23 March 2006

RE: Addendum 4 to Geotechnical Investigation Report Proposed City Library Mt. Diablo Boulevard at First Street Lafayette, California

PROJ NO. 030400 MARCH 2006 FIGURE 1

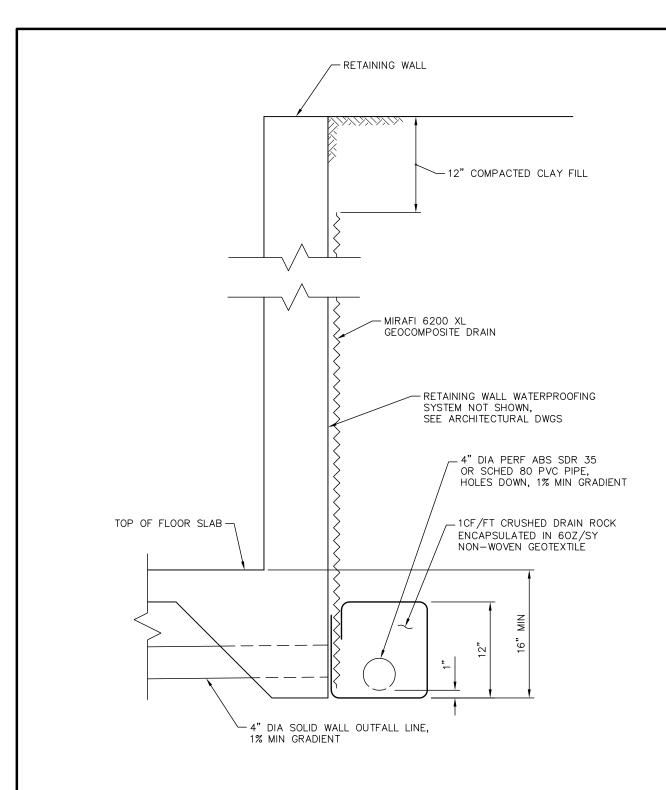
For the permanent retaining walls and shoring configurations where lateral bracing of the walls will occur, we recommend that a trapezoidal pressure of 50H (given in pounds per square foot for wall height, H, in feet) should be used to design the permanent laterally braced retaining walls. This value is unfactored, but accounts for seismic loads and vehicular surcharge. The uniform pressure of 50H noted should be applied uniformly over the central six-tenths of the wall and decreased to zero at the top and bottom of the wall. This lateral loading configuration is shown diagrammatically on Figure 1.

FIGURE 2

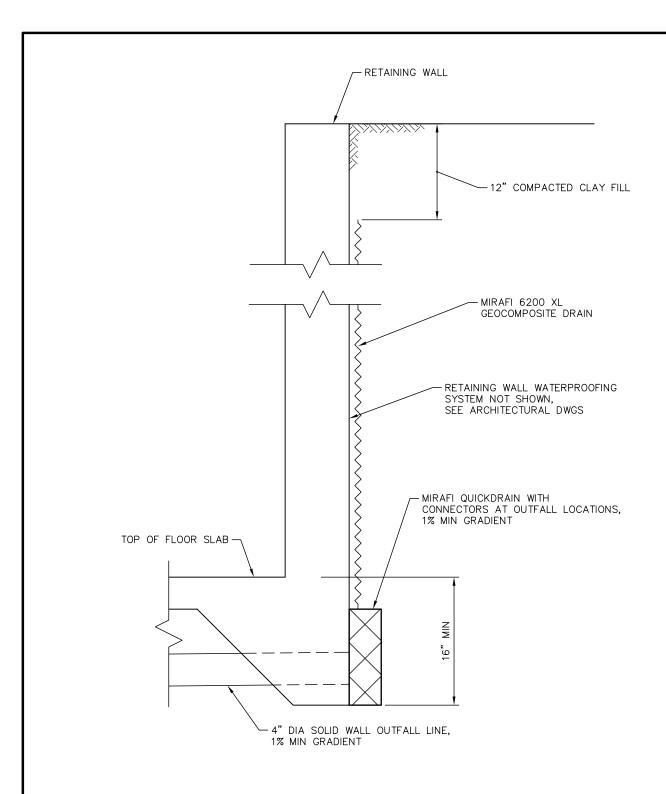
Drainage recommendations for permanent retaining walls are listed in the *Retaining Wall* section on pages 11 and 12 of our 21 May 2003 report. These recommendations remain applicable to the project, except that the gradient of pipes may be reduced to 1 percent from 2 percent, if necessary. The attached Figures 2 and 3 provide generalized details of the alternatives discussed on pages 11 and 12 of the 21 May 2003 report.

FIGURE 3

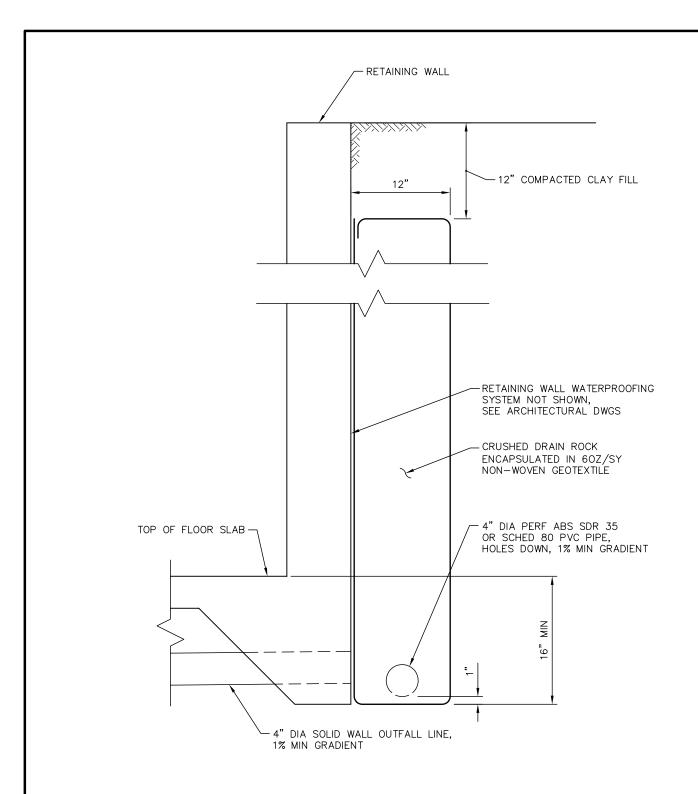
If property line constraints do not provide sufficient space to use a conventional 4 inch diameter collection and outfall pipes at the base of the retaining wall, then it would be acceptable to use a geocomposite "flat pipe" and connectors as an alternative. Mirafi's QuickDRAIN product and the appropriate connectors or equivalent are recommended. A detail for this alternative is provided as Figure 4.
